Nº 142 SERVICE BULLETIN

SUBJ: T3™ Auto Launch Wire(s) or Coil Lug(s) Break Off

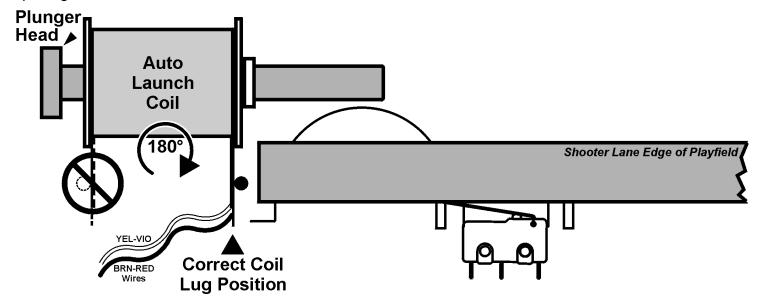
The **Auto Launch Coil** is not functioning. Customer pulls *gun trigger* to launch ball and the Auto Launch Coil does not fire.

One of the Auto Launch Coil Wires has broken off the Auto Launch Coil Lug. This is due to the extreme amount of vibration produced by the *Plunger Head* hitting the *Coil Retaining Bracket* and the wires being dressed too tight (the wire or coil lug can break off).

Reverse the position of the coil (rotate 180°) so that the coil lugs are on the opposite side of the coil retaining bracket. While inspecting the Auto Launch Assembly, ensure that the coil wires are not pulled too tight which can cause breakage at the lugs due to vibration. Create more slack by gently pulling the wires from the harness.

All Games Manufactured *prior to AUGUST 2003* require this modification or refer to the drawing to determine the coil lug position on your game.
